INDIANA DEPARTMENT OF TRANSPORTATION

APPROVED MINUTES

August 18, 2011 Standards Committee Meeting

RE: Minutes from the August 18, 2011 Standards Committee Meeting

805-TSCS-04 TRAFFIC SIGNAL CANTILEVER STRUCTURE SIGNAL ARM CONNECTION DETAILS

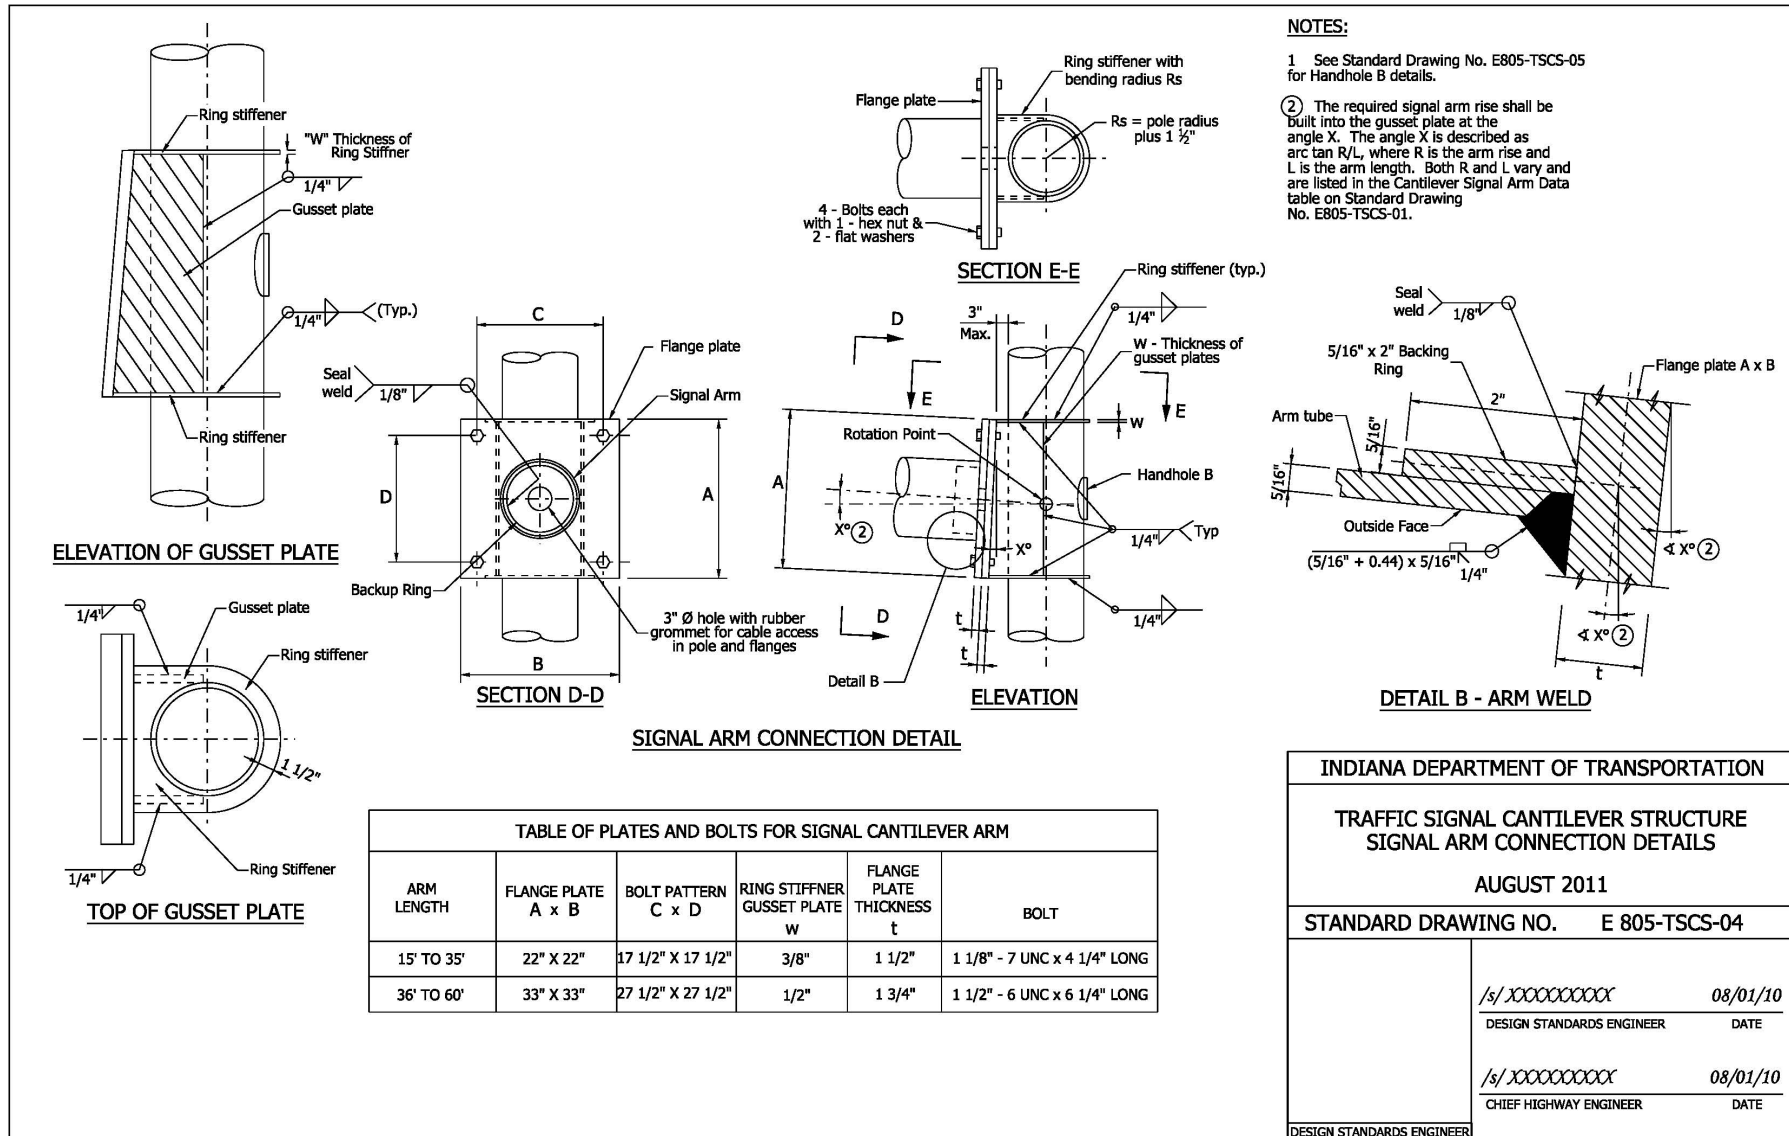
Mr. Uremovich had some questions on the standard drawings. Beginning with drawing E 805-TSCS-04 - note 2 - the required signal arm rise..... Mr. Uremovich would like to it to say "shall" instead of "will" and have it say it shall be built "at" and angle, not "as" an angle. Mr. Patel will incorporate those revisions.

STANDARD DRAWING NO. E 805-TSCS-06

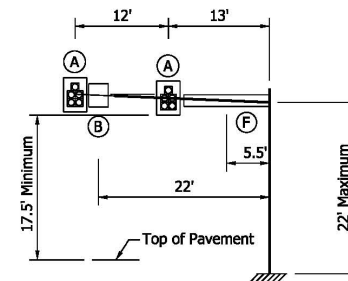
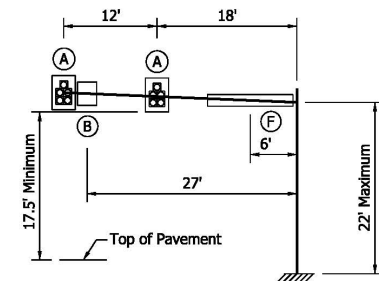
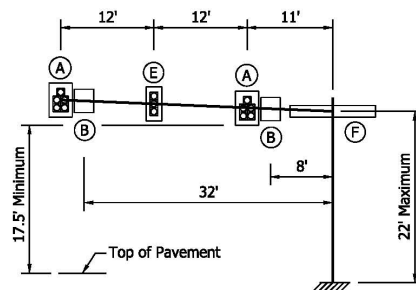
Mr. Strain inquired as to the minimal clearance under a signal head and reference sheet E 805-TSCS-06 of the drawings. The drawing shows 17.5 ft minimum clearance, but the spec shows 17 ft. Mr. Patel agreed to revise that clearance to 17.5 feet in section 805.05 of the spec. Mr. Patel also pointed out some of the editorial changes that were made to the revised 805 section. Mr. Uremovich pointed out that the "M" should be capitalized in MPa.

805-TSCS-15 TRAFFIC SIGNAL CANTILEVER STRUCTURE DRILLED SHAFT FOR ARMS 35' OR LESS TYPE A

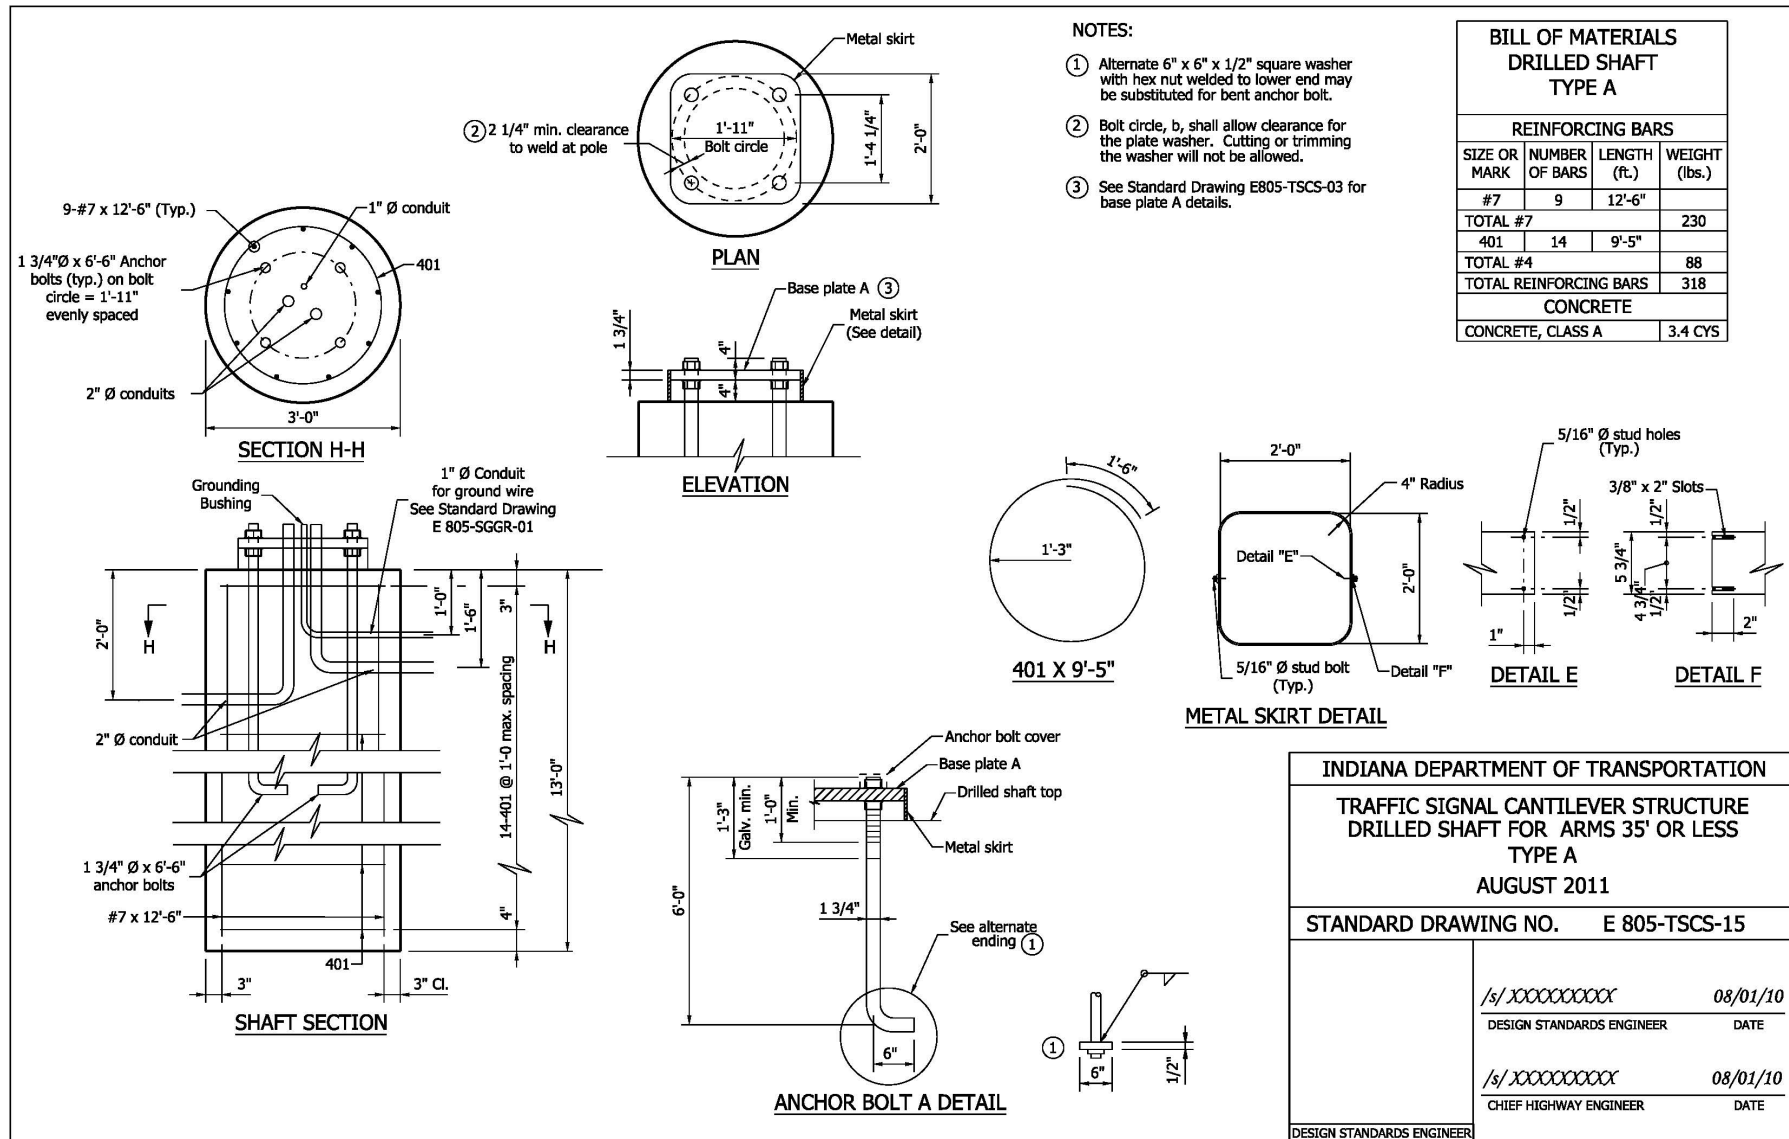
Mr. Keefer pointed out that the drawings should say "Drilled Shaft **Foundations**" instead of just "drilled shaft", in the title block. Mr. Keefer also made some editorial suggestions which are shown on page 8 of these minutes, in section 805.13 Foundations. The words *concrete* and *placed* were added. Mr. Walker and Mr. Uremovich made some other editorial recommendations for section 922.01, clarifying the language, which were incorporated during the meeting.
